File No.: 8-08/2025-FC Government of India Ministry of Environment, Forest and Climate Change (Forest Conservation Division)

Subject: Proposal for seeking Ex-post facto approval of the Central Government under Section 2 (1) (ii) of the Van (SanrakshanEvamSamvardhan) Adhiniyam, 1980 for diversion of 133.69 Ha Forest land in Muraidih Colliery having Leasehold area of 717.71 Ha for Opencast and Underground Coal Mining Project of M/s Bharat Coking Coal Limited under Dhanbad District of Jharkhand State (Online Proposal No: FP/JH/MIN/44804/2020).

DSS map showing the presence of Notified forest land (RF/PF) in the Project area:

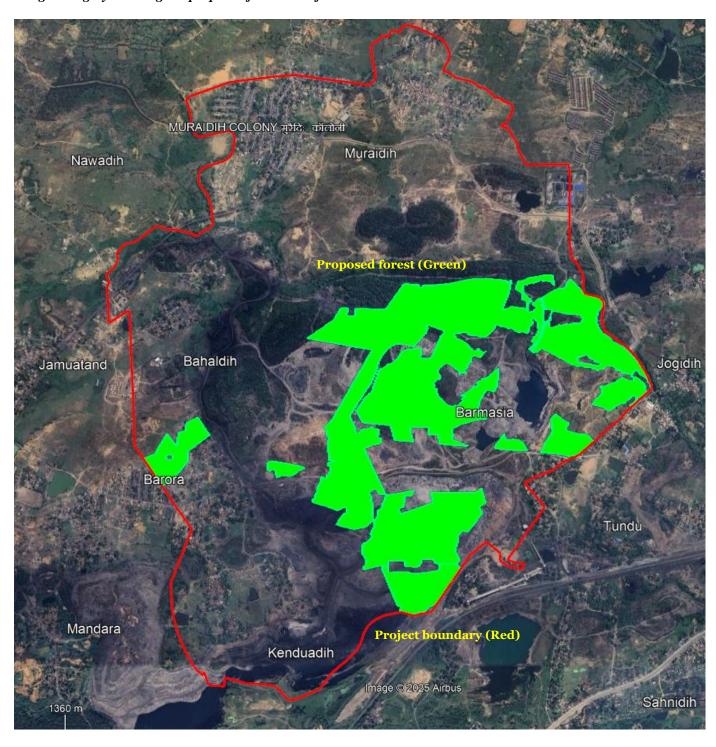
- c. On examination of KML file of the mining lease boundary through the Decision Support System (DSS), it has been observed that the total notified forest land (Reserved Forest/Protected Forest) within the project boundary of 717.71 ha is 59.91 ha. However, the State Government, in the instant proposal, has reported the extent of notified forest land (RF/PF) within the lease/project area as 46.17 ha. The entire extent of forest land falling within the project area shall be duly included in the proposal.

- 8. The user agency has uploaded the KML file of Mining lease boundary and the total project area through its KML file is found 717.711 ha. Further, as per the forest compartment boundary available on PARIVESH, total notified forest land (RF/PF) within the project boundary is found 59.91 ha whereas the State Govt in the instant proposal reported that the total Notified forest (RF/PF) land within the lease/ Project area is 46.17 ha. Hence, less Notified forest land has been applied for diversion.

Google imagery showing the proposed forest land for diversion:

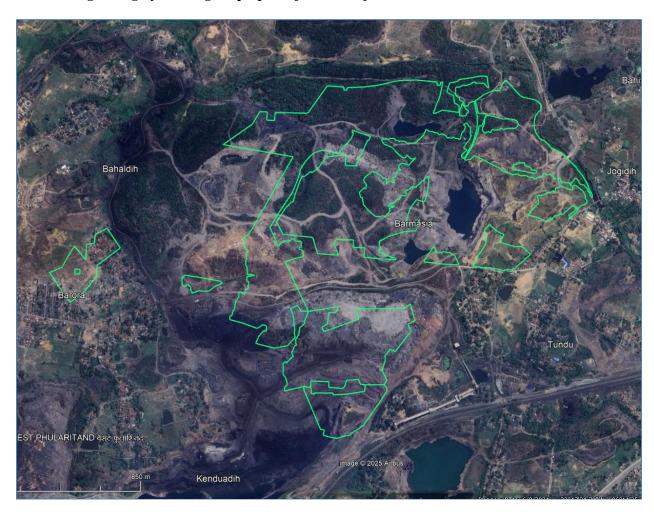
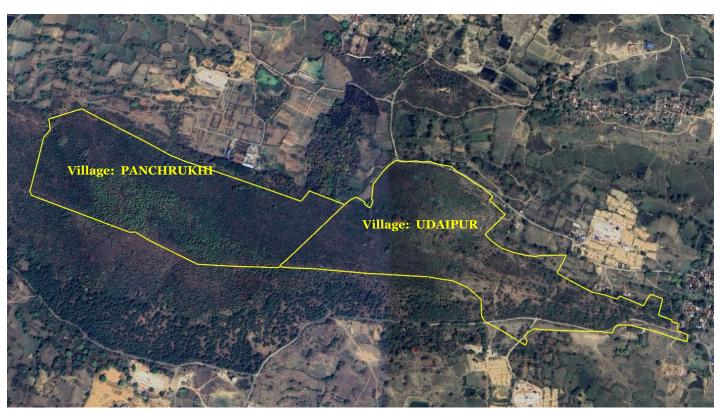
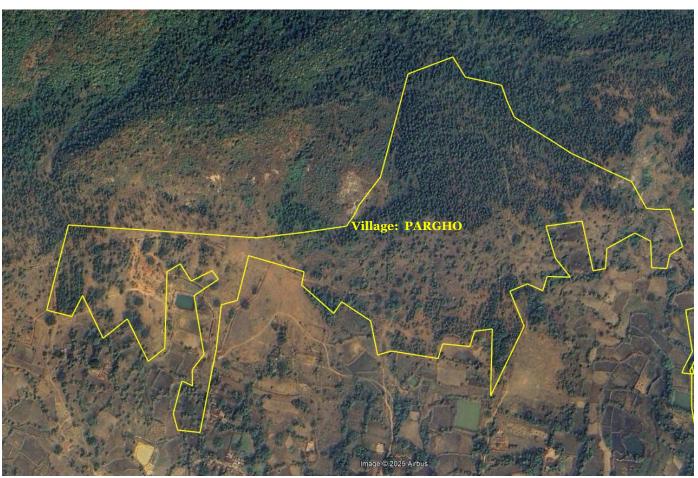
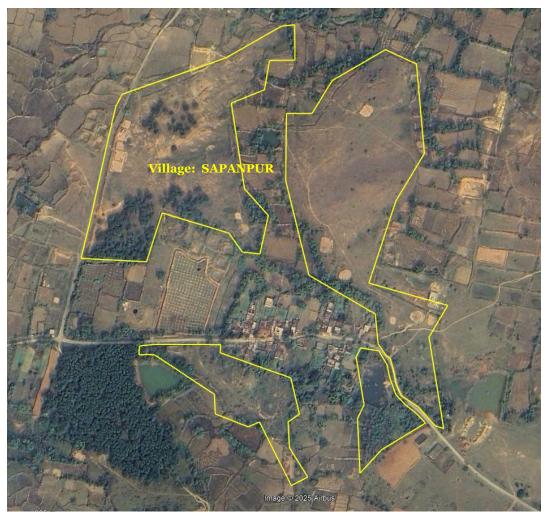
- 6. The Satellite imagery shows the presence of Khudia Nadi adjacent to the forest land proposed for diversion. The copy of NoC/comments from the Water Resource Department, Govt. of Jharkhand in this regard shall be submitted along with the details of proposed mitigation measures.

- b. Satellite imagery shows the presence of Mined out area, Agricultural lands, Settlement, Construction of new Road and some forest areas wherein mining activity is going on. This needs justification.

- 4. High resolution satellite imagery shows the presence of Mined out area, Agricultural lands, Settlement, Construction of new Road and some forest areas wherein mining activity is going on.

- 5. The Satellite imagery shows the presence of Khudia Nadi in adjacent to the forest land proposed for diversion.
- 6. The instant proposal falls under Not In high conservation zone value as per DSS Rule 2. However, In High Conservation Zone as per DSS Rule-I due to presence of Khudia Nadi in adjacent to the forest land proposed for diversion. The final result would be Not In High Conservation Zone.

Google imagery showing the Forest land for CA:

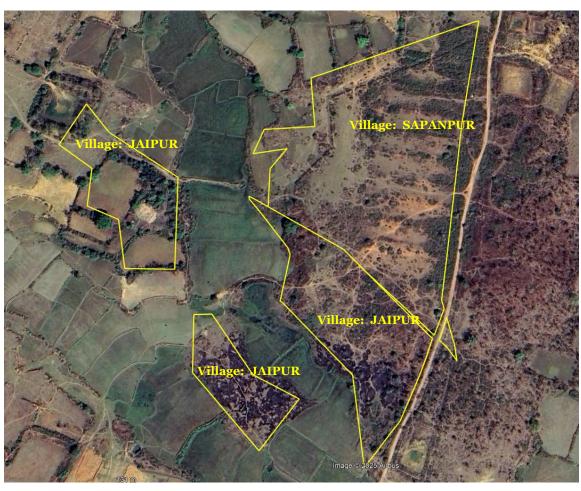
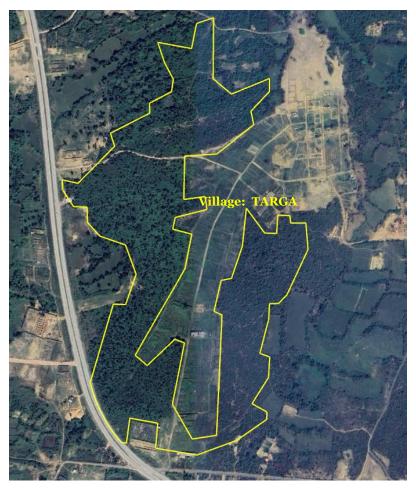
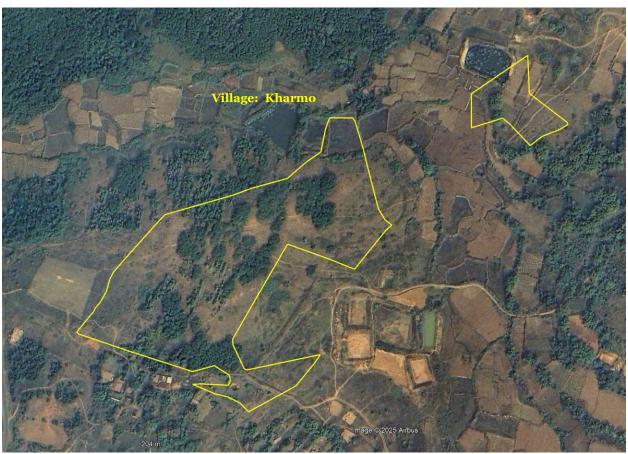
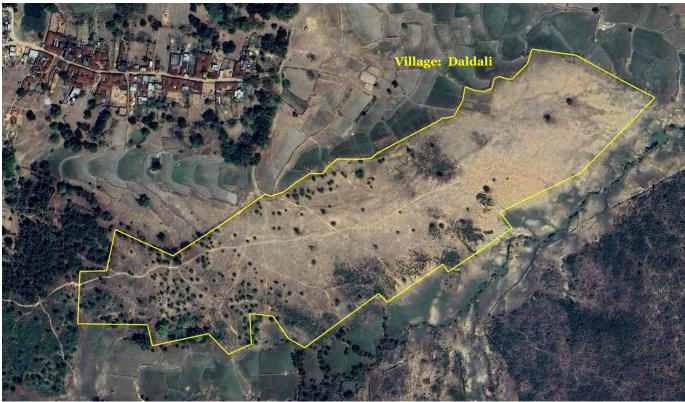
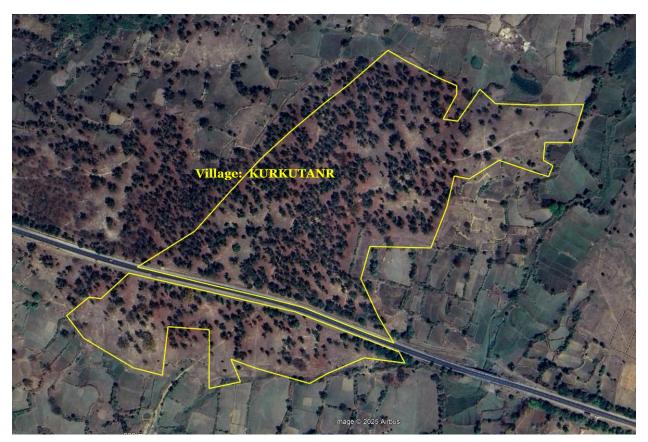
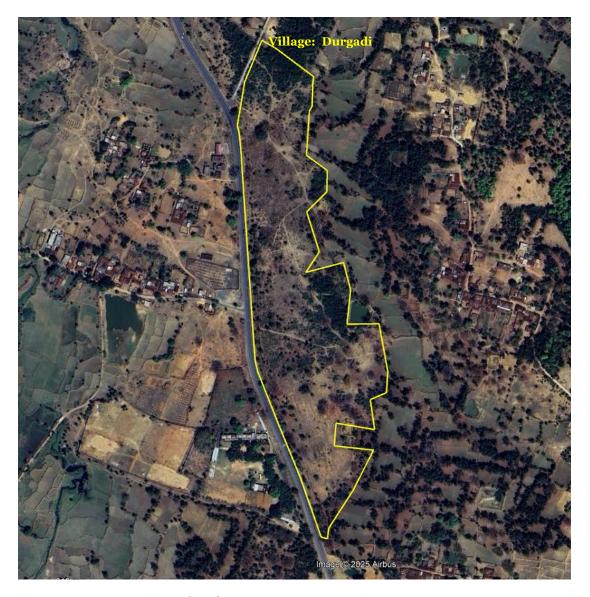
- d . A total of 57 patches have been proposed for Compensatory Afforestation (CA). It has been observed that some of the proposed CA sites are affected by encroachment, while some patches are less than 5 ha in area. The State Government shall ensure that the CA areas identified are suitable for plantation activities and are free from all encumbrances. The revised details of the CA sites shall be updated accordingly in Part-II of the PARIVESH portal, along with the relevant maps, CA scheme, KML files, and other supporting documents.

- 6. **Forest Cover in CA land:** 21 ha is Moderately Dense Forest, 62 ha is Open Forest, 12 ha is Scrub and 172 ha is Non Forest (Non-wooded) in terms of forest classes (as per the ISFR 2021) based on the interpretation of satellite data period 2019.
- 7. The Google imagery shows that, some of the proposed CA sites are having encroachment in form of Agriculture land, Settlements, Non-Forestry activity and Plantation work carried out recently. The details of those CA patches are as under:
